June 24, 2024

To: Plan Holders for Improvements to the
KIRKSVILLE REGIONAL AIRPORT
KIRKSVILLE, MISSOURI
MODOT PROJECT NO. 24-028A-1

**ADDENDUM NO. 5
TO
CONTRACT DOCUMENTS, SPECIFICATIONS AND PLANS
FOR IMPROVEMENTS TO THE
KIRKSVILLE REGIONAL AIRPORT
KIRKSVILLE, MISSOURI
MODOT PROJECT NO. 24-028A-1**

A-111

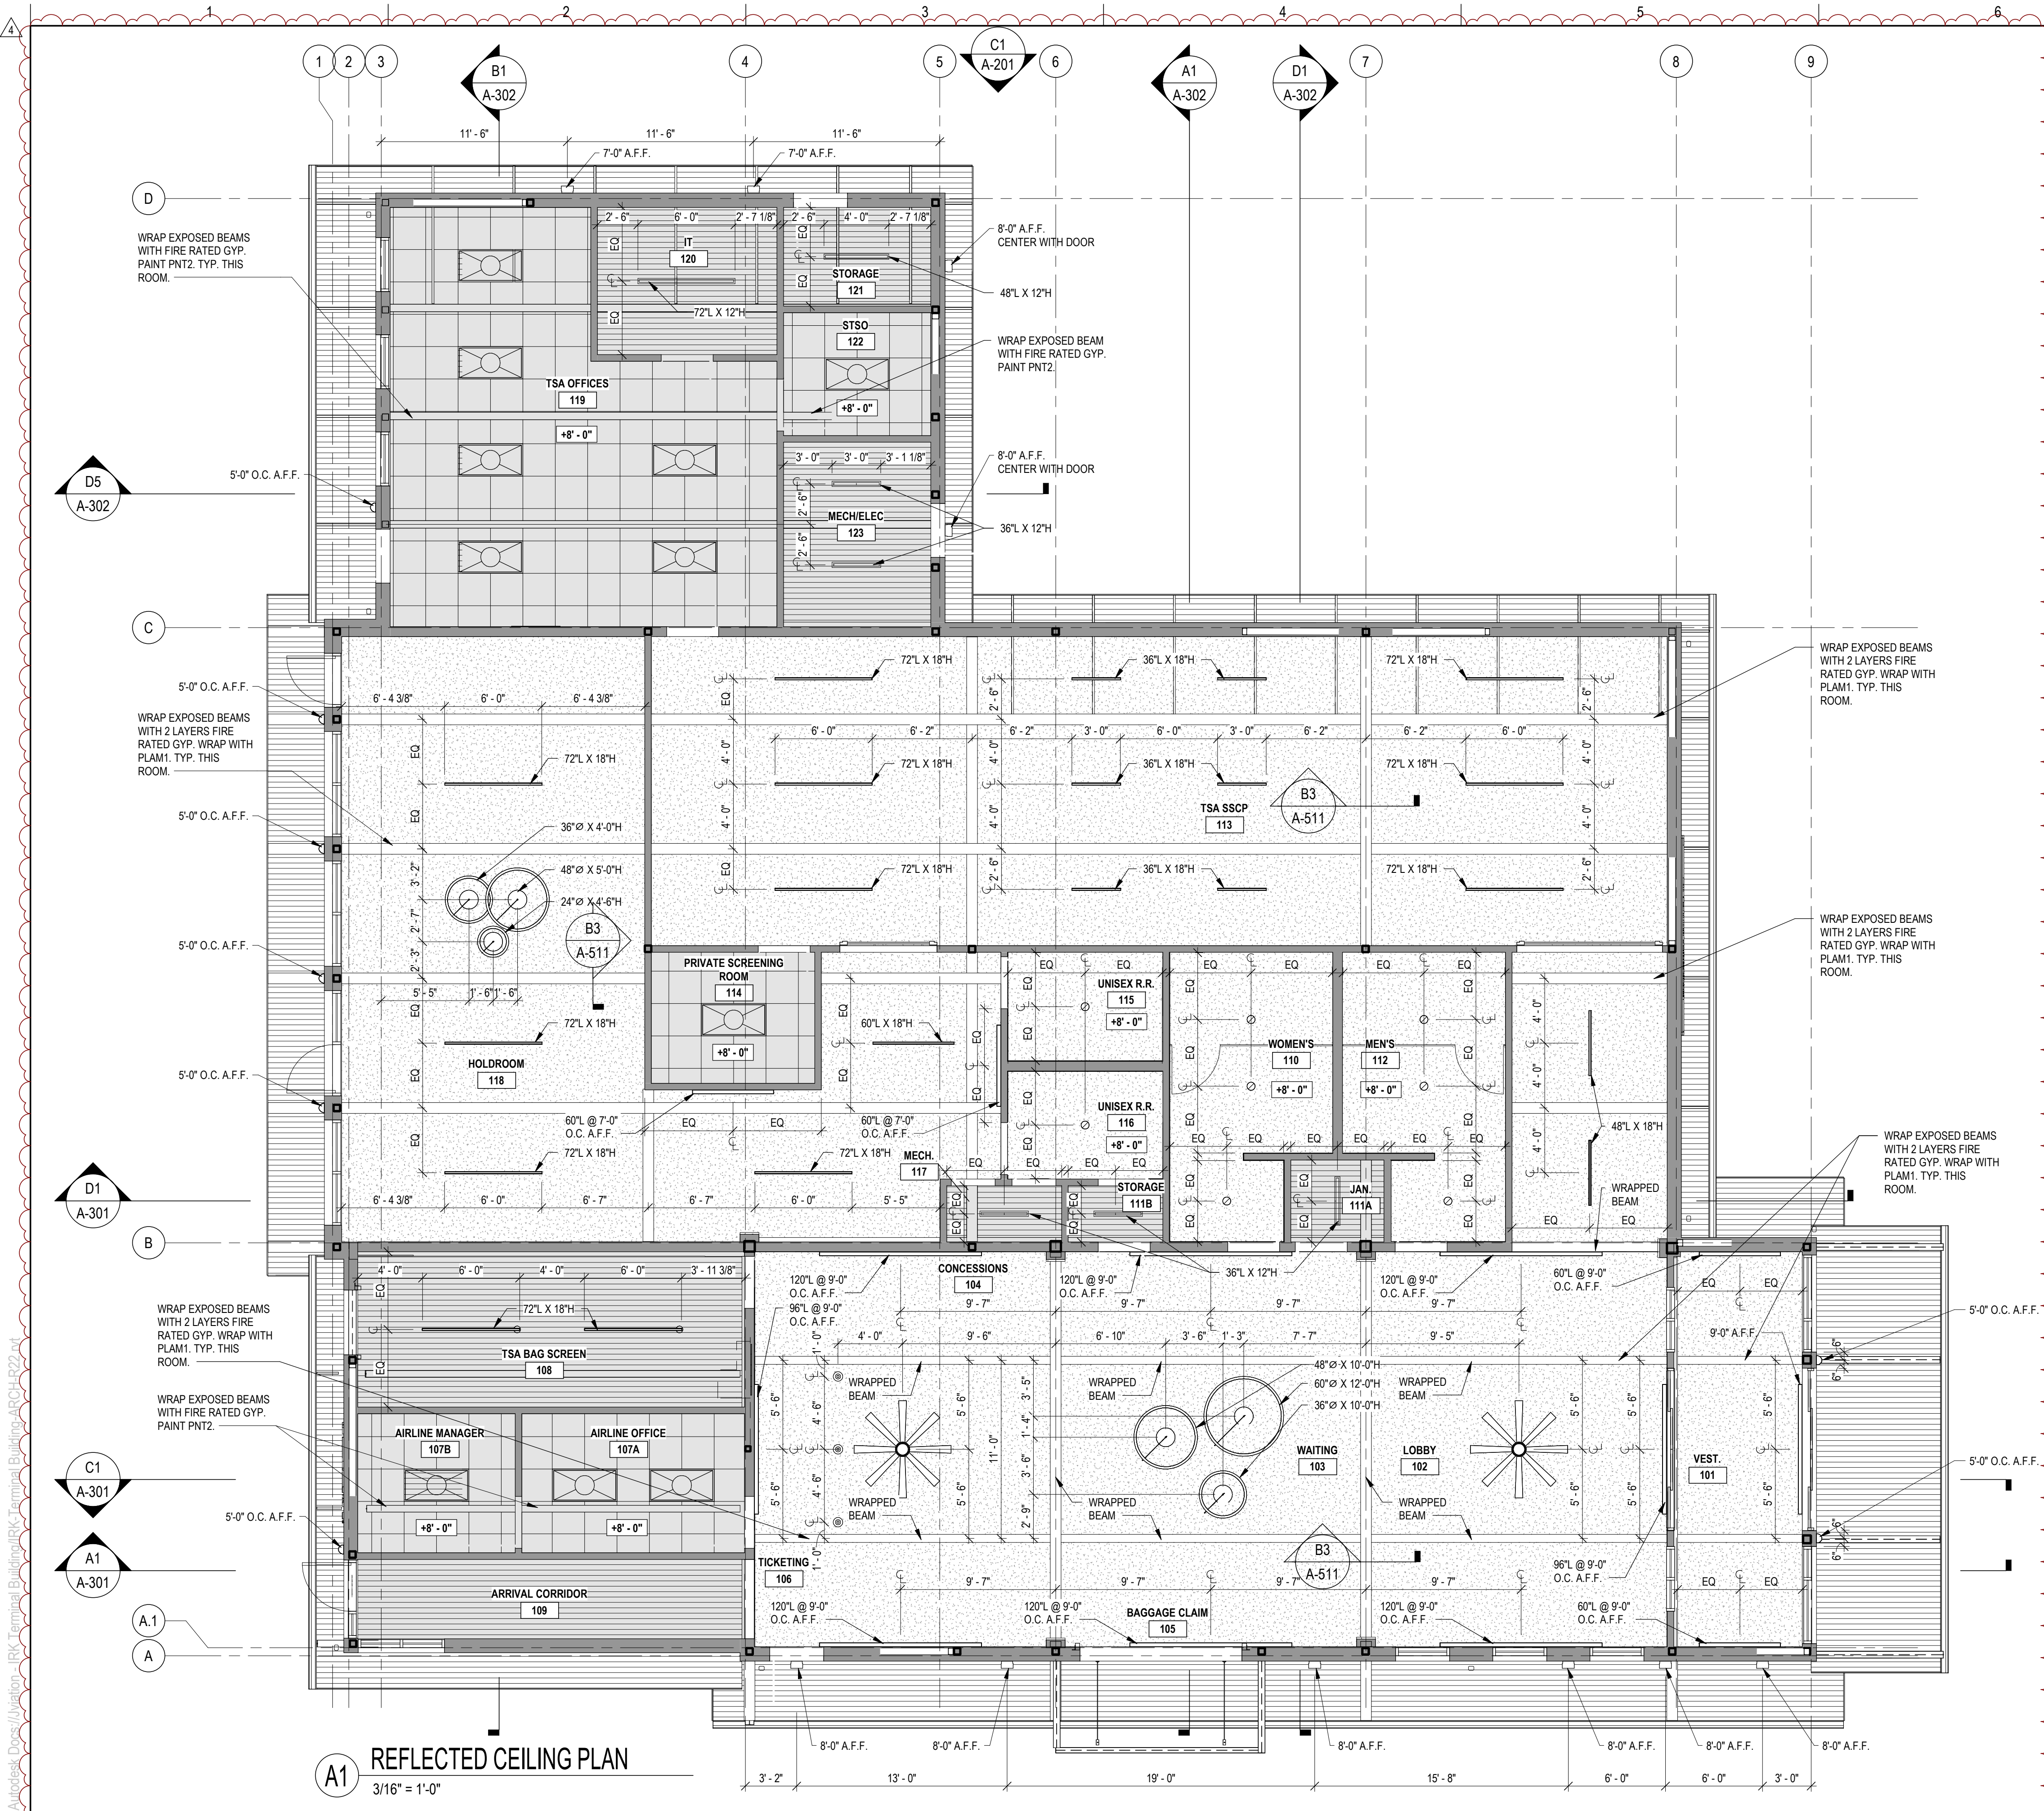
Sheet No.: A-111
Title: FIRST FLOOR REFLECTED CEILING PLAN
Revision: Extents and locations of different fire proofing have been updated.
Justification: For clarity.

A-402

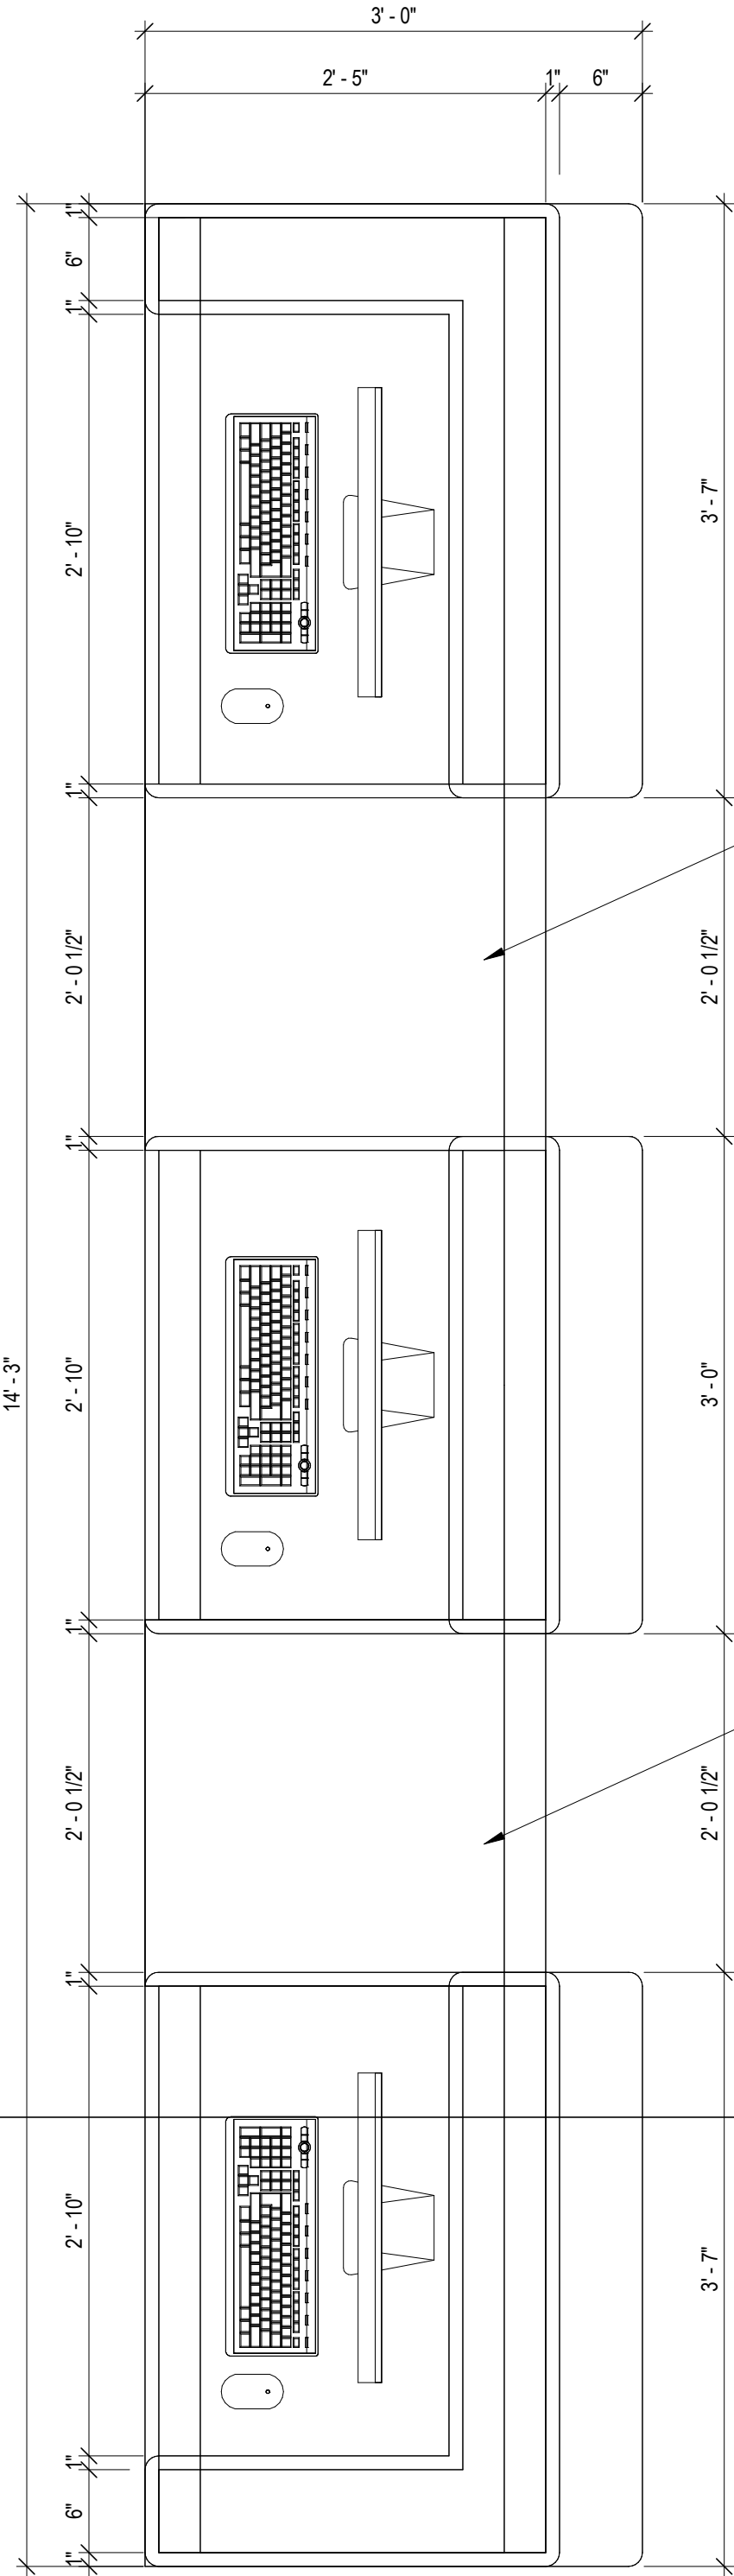
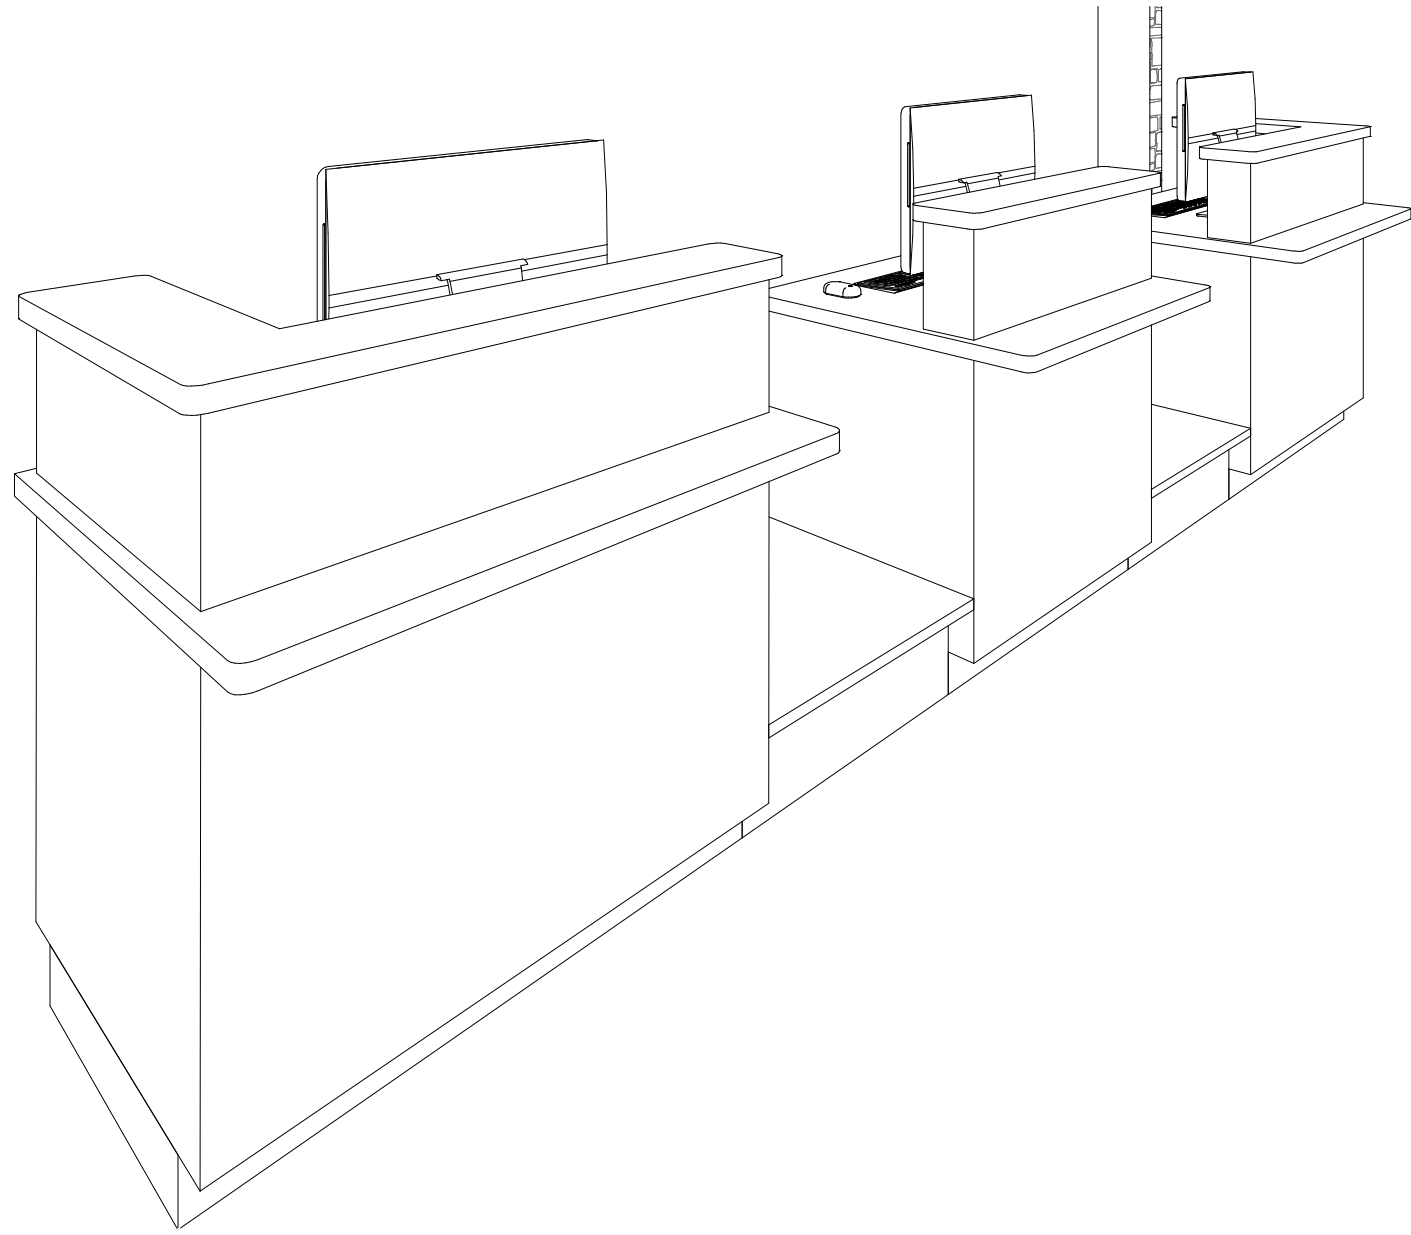
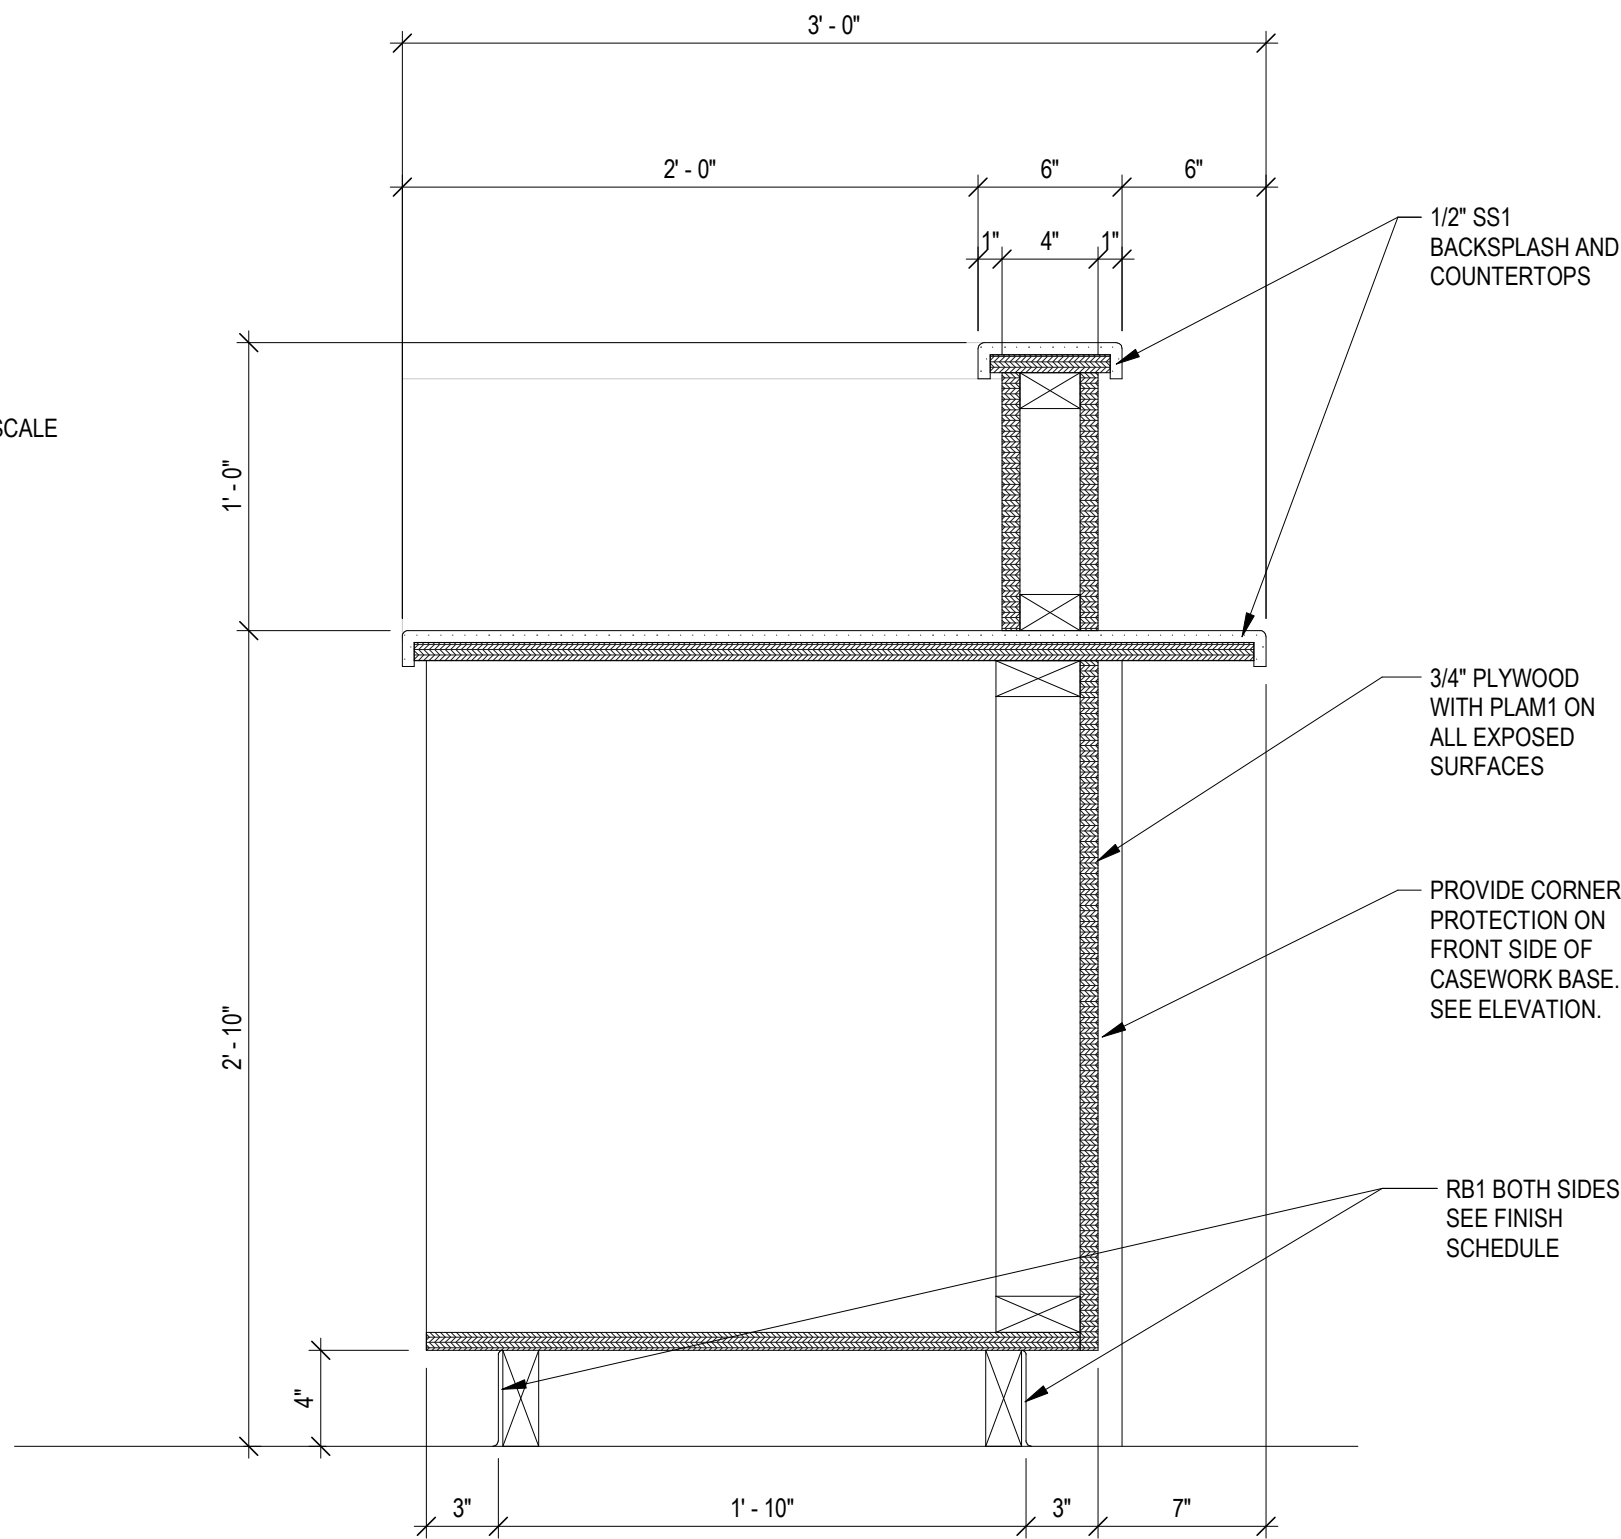
Sheet No.: A-402
Title: ENLARGED TICKETING COUNTER PLAN AND DETAILS
Revision: Ticket Counter details have been revised.
Justification: For clarity.
